Expected Performance of the Pottstown Landfill Containment and Monitoring Systems

G. Fred Lee, PhD, PE, DEE and Anne Jones-Lee, PhD

March 2005

Figure 6

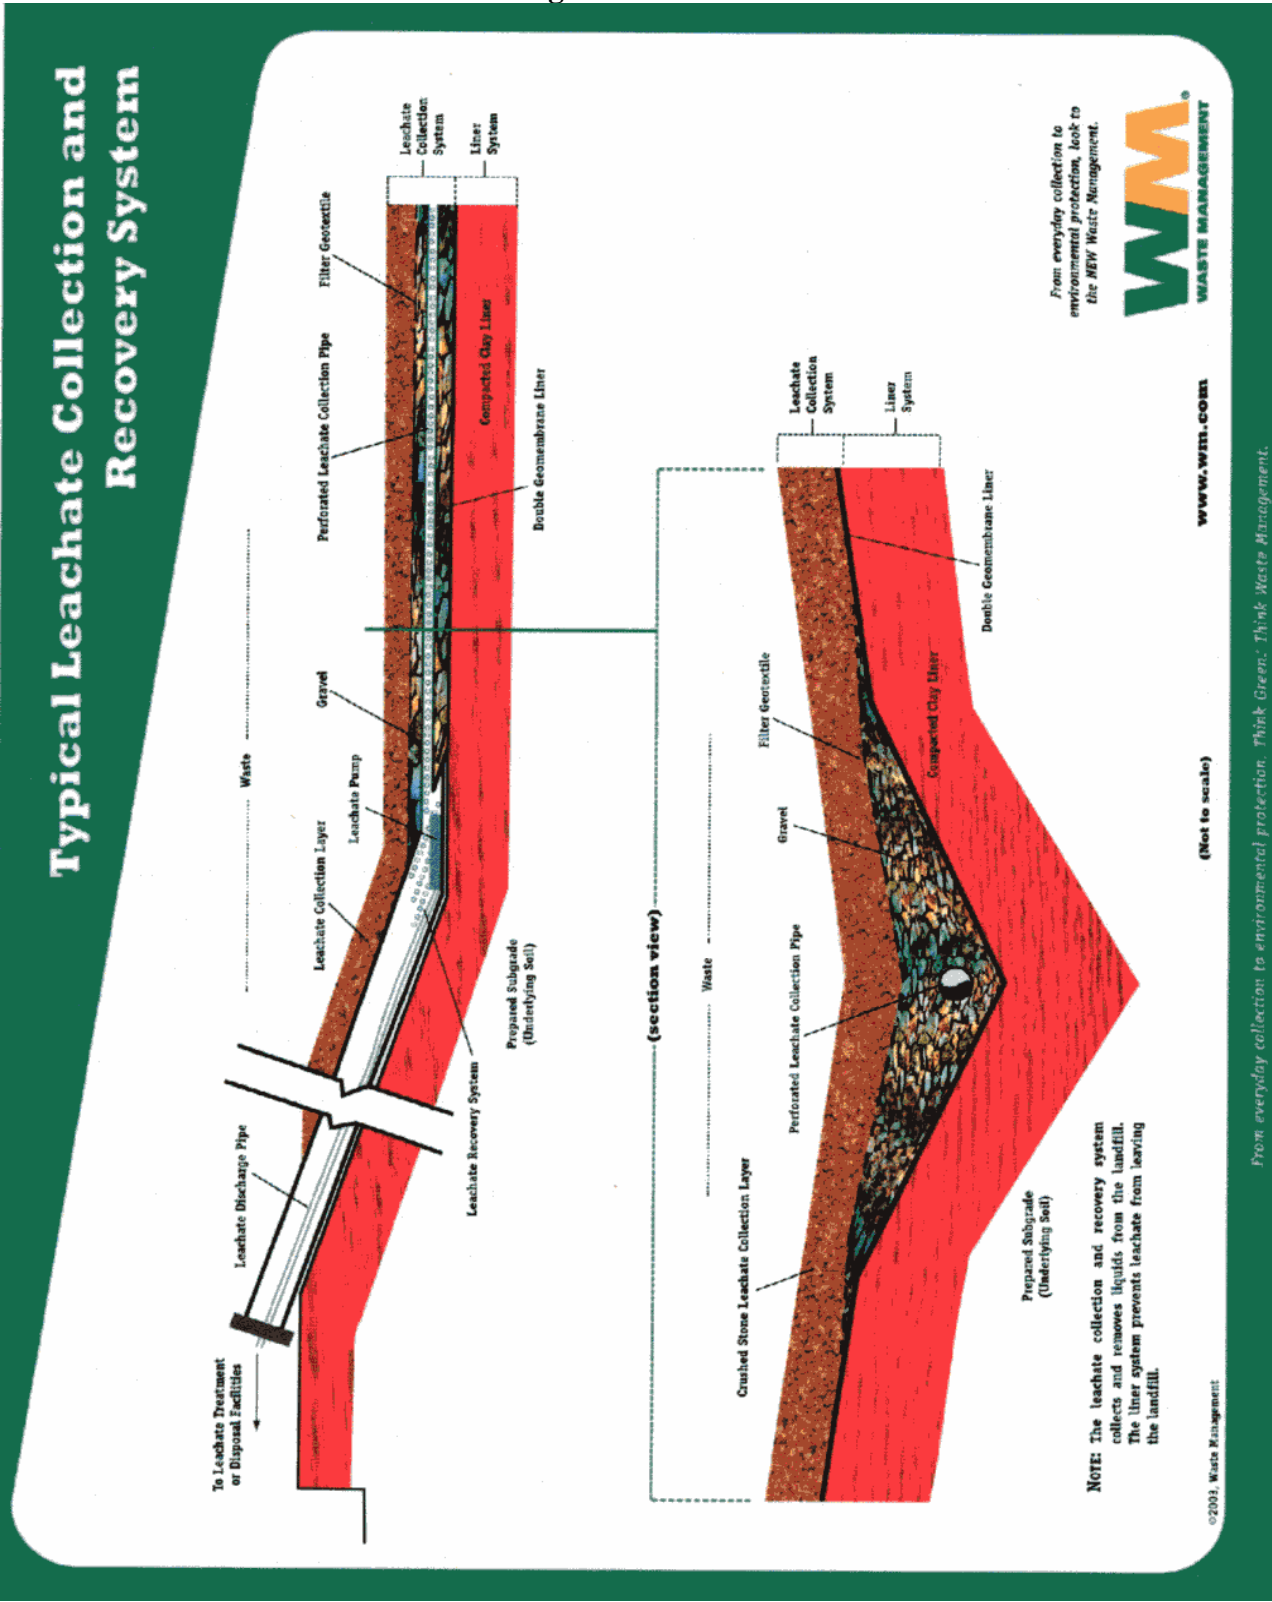
Figure 5 presents a detailed breakdown of the components of the Pottstown Landfill liner system that has been installed since Waste Management purchased the landfill. The compacted soil base of the Pottstown Landfill liner system is overlain by “non-woven geotextile” (see Figure 5) that separates the secondary plastic sheeting liner (secondary liner) from the soil base. One of the problems with the PA landfilling regulations is that it allows the incorporation of the geotextile between the secondary plastic sheeting liner and the compacted soil base. This arrangement destroys the composite liner characteristics of the secondary liner; in order to achieve the double composite liner level of protection the plastic sheeting layer must be in intimate contact with underlying compacted clay/soil liner. Daniel (1990) summarized the properties of composite liners verses double liners. He pointed out that a true composite liner – with the plastic sheeting liner in contact with the compacted soil/clay liner – limits the area of the compacted soil through which leachate that penetrates through holes in the plastic sheeting liner, can migrate. In the Pottstown Landfill, placement of geotextile between the plastic sheeting and the compacted soil layer allows leachate that penetrates through the holes, rips, tears and/or points of deterioration in the plastic sheeting liner, to pass into the geotextile space between the plastic sheeting and the compacted soil layer. It then spreads out over the compacted soil layer. This allows a larger area for leachate to pass through the

compacted soil layer than would occur if the plastic sheeting and compacted soil were in intimate contact in a true composite liner design. The net effect of this problem is that the secondary liner can leak at a higher rate through holes that develop in the plastic sheeting secondary liner than would occur if a true composite liner design had been required in the secondary liner design.

While PA regulations allow the design of the leak detection zone with a plastic sheeting secondary liner separated from the compacted soil layer, such a design has important implications for the reliability of leak detection zone to transmit leachate on the plastic sheeting layer to a leak detection zone sump where it can be removed/monitored. The greater rates of leakage of the plastic sheeting layer in the PA DEP allowed secondary liner system design means that there is a greater potential for leachate that reaches the secondary plastic sheeting liner to pass through the liner and then escape from the landfill into the underlying groundwater system.

Another potential problem with the Pottstown Landfill leak detection zone is that a geonet used to allow the leachate that passes through the primary liner rather than a layer of porous sand that is used in some leak detection zones. Municipal solid waste leachates contain chemicals that tend to form precipitates that tend to plug leachate transmission layers. Also, biological growths can develop in the leachate transmission layer such as a geonet or sand layer. This plugging would tend to be more significant in thin leachate transmission layers such as geonets. The plugging of the geonet layer used in the leak detection zones in the liner system that is used in some sections of the Pottstown Landfill would tend to make the leak detection zone system less likely to indicate when the upper primary liner systems has failed.

Overlying the geonet in the Pottstown Landfill leak detection zone is geotextile (see Figure 5) which is overlain by a bentonite layer. The bentonite layer is a thin layer of bentonite clay. It is allowed as the equivalent of two feet of compacted clay with a permeability of equal to or less than 1×10^{-7} cm/sec. While states allow the substitution of a very thin bentonite layer for two feet of compacted clay, as discussed by Lee and Jones-Lee (2005) there are several reasons that such a substitution may not, in the long term, provide the same degree of protection as a two-foot-thick clay layer. This issue is discussed further below.

The primary plastic sheeting liner (Figure 5) is of the conventional, minimum design allowed by US EPA Subtitle D for a high density polyethylene (HDPE) liner in municipal solid waste landfills. Lee and Jones-Lee (2005) reviewed the current information on the long term stability of such liners. The following section is derived from their review.

If a true double composite liner system were used as the base of the leak detection zone, the potential for oxygen-derived radicals to reach the secondary plastic sheeting layer would be reduced and the leak detection zone would work more in accord with its design function. The deficiencies in the leak detection zone design allowed in PA mean that there is a greater probability that the leak detection zones used in various sections of the Pottstown Landfill will not provide reliable information on when the primary liner systems has failed by allowing leachate to pass through it.

Figure 7

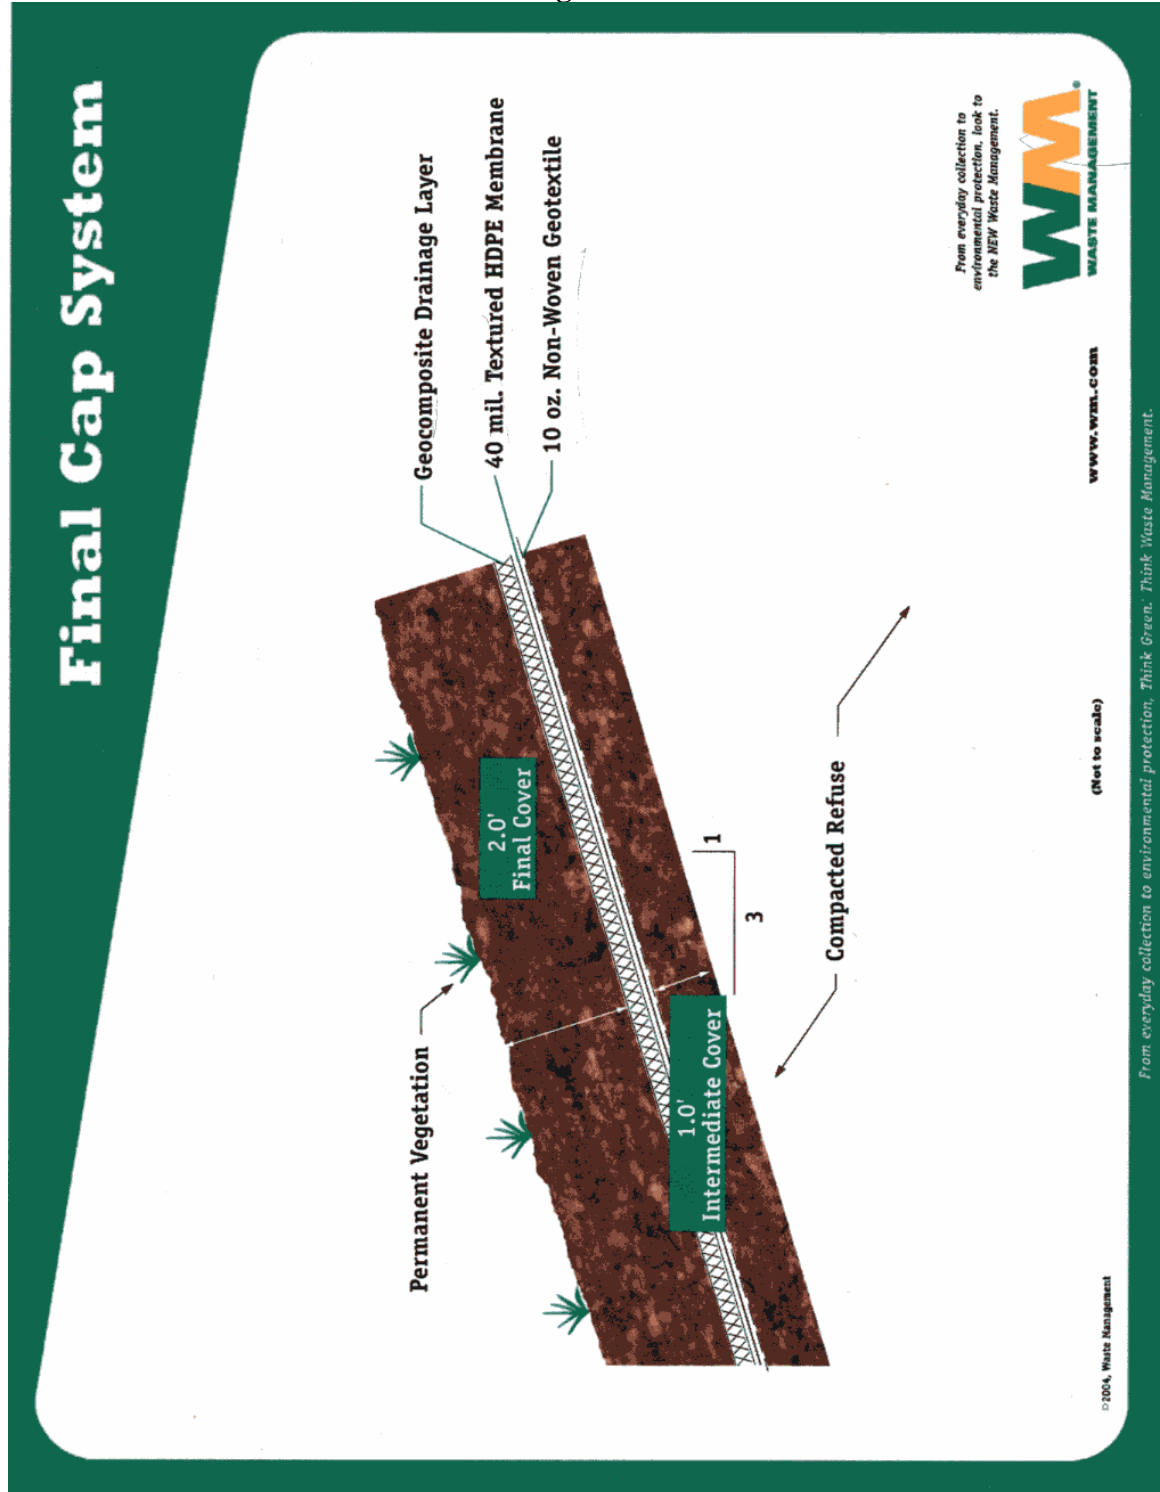
Waste Management (2004) provided the Pottstown Landfill Closure Committee with Figure 7 showing the Pottstown Landfill final cap for part of the landfill. The cover that Waste Management is now using for newer parts of the landfill is consistent with typical Subtitle D landfill covers. Starting from the top, it consists of a two foot thick vegetative soil layer. Under lying the top soil layer is a drainage layer. Underlying the drainage layer is a geocomposite drainage layer which is underlain by a 40 mil HDPE plastic sheeting layer. The plastic sheeting layer of the cover rests on geotextile layer that is placed on a soil layer that is used to shape the area above the wastes so that it is more suitable for placement of the final cover.

In principle, this landfill cover is supposed to allow part of the moisture that falls on the vegetative layer of the landfill to penetrate through the root zone of the vegetation in this layer to the porous (drainage) layer. When the moisture reaches the low-permeability plastic sheeting layer beneath, it is supposed to move laterally to the outside of the landfill.

A significant problem with landfill covers of this type is that they cannot be effectively monitored to detect when moisture leakage through the cover occurs. The typical monitoring approach that is advocated by landfill owners and operators, and allowed by regulatory agencies, involves a visual inspection of the surface of the vegetative soil layer of the landfill cover. However, as discussed by Lee and Jones-Lee (1995, 1998a, 2005), since the low-permeability layer (plastic sheeting) is buried below a topsoil layer and a drainage layer, it is not possible to detect when the plastic sheeting layer deteriorates sufficiently to allow moisture that enters the topsoil and drainage layer to pass into the landfilled wastes. Those cracks or depressions that are observed in the topsoil layer are filled with soil. Such an approach will not detect cracks in the plastic sheeting layer. As a result, the moisture that enters the drainage layer and comes in contact with the plastic sheeting layer will penetrate into the wastes rather than run off the landfill as it could when the plastic sheeting is new and constructed properly. Breaches in the plastic sheeting could occur at any time during the postclosure care period. If the leachate collection system is still functioning when it does, the increased leachate generation would be noticed there. However, if the leachate collection system is not functioning adequately, or if no one is monitoring leachate generation (as would occur if postclosure care is limited to a period less than when the wastes in the landfill are still a threat to generate leachate) that collects in the leachate collection system would not be removed and would pollute groundwater.

Leak-Detectable Covers. The high probability of failure of the low-permeability layer of the landfill cover is the reason that Lee and Jones-Lee (1995) advocate the use of leak-detectable covers that are operated and maintained in perpetuity – i.e., as long as the wastes in the landfill are a threat. This approach requires that a dedicated trust fund be developed that is of sufficient magnitude to ensure that, at any time in the future while the wastes are still a threat (typically, forever), leaks in the cover can be isolated and repaired.
